Access Compliance Report

Public Rights-of-Way

(Curb Ramps)

Intersection ID: 2940	Main Street: DOWNFIELD_WOOD_DR	Cross Street: HARBURN_FOREST_DR	Location:	E
ADA ID: 9780B5F18C6B	Ramp Type: Perp	Initial Pass/Fail: Fail	Overall Compliance: No	Severity Score: 8.75
Codes/Mitigation Info/Possible Solution		Field Measurements/Component Compliance

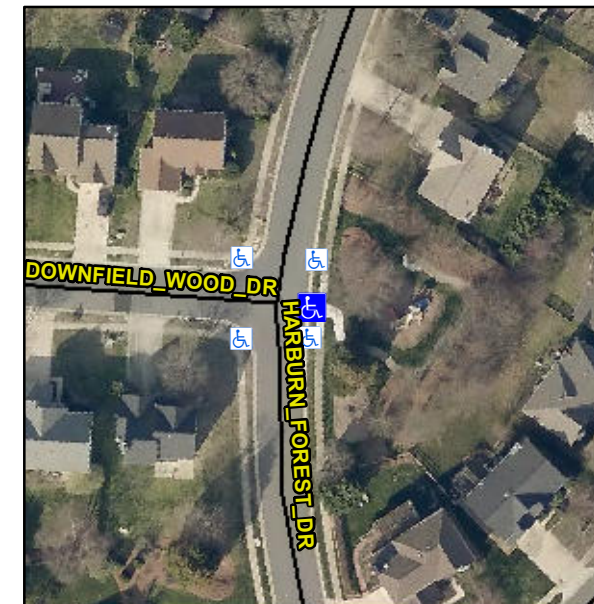
Not Found, R304.5.1

Compliance	Description	Data	Compliance	Description	Data
N/A	Ramp Length (in)	48.0	Yes	Ramp Slope (%)	6.7
No	Ramp Width (in)	47.0	Yes	Ramp XSlope (%)	1.2
N/A	Flare Type LT	N/A	N/A	Flare Type RT	N/A
N/A	Flare Slope LT (%)	N/A	N/A	Flare Slope RT (%)	N/A
N/A	Flare Traversable LT?	N/A	N/A	Flare Traversable RT?	N/A
N/A	Landing Length (in)	N/A	N/A	DWS Provided?	N/A
N/A	Landing Width (in)	N/A	N/A	DWS Contrast?	N/A
N/A	Landing Slope (%)	N/A	N/A	DWS Length (in)	N/A
N/A	Landing X Slope (%)	N/A	N/A	DWS Full Width?	N/A
N/A	Landing Curb? (Y/N)	N/A	N/A	DWS Offset (in)	N/A
N/A	Shared Landing?	N/A			
N/A	Gutter Ponding?	N/A	N/A	Gutter Slope (%)	N/A
N/A	Gutter Lip Ht (in)	N/A	N/A	Gutter X Slope (%)	N/A
N/A	Painted X Walk1?	No	N/A	Painted X Walk2?	N/A
	X Walk 1 Direction	To W		X Walk 2 Direction	N/A
N/A	X Walk 1 Width (in)	N/A	N/A	X Walk 2 Width (in)	N/A
	X Walk 1 Slope (%)	3.5		X Walk 2 Slope (%)	N/A
	X Walk 1 X Slope (%)	1.2		X Walk 2 X Slope (%)	N/A

Remove & Replace Entire Ramp.
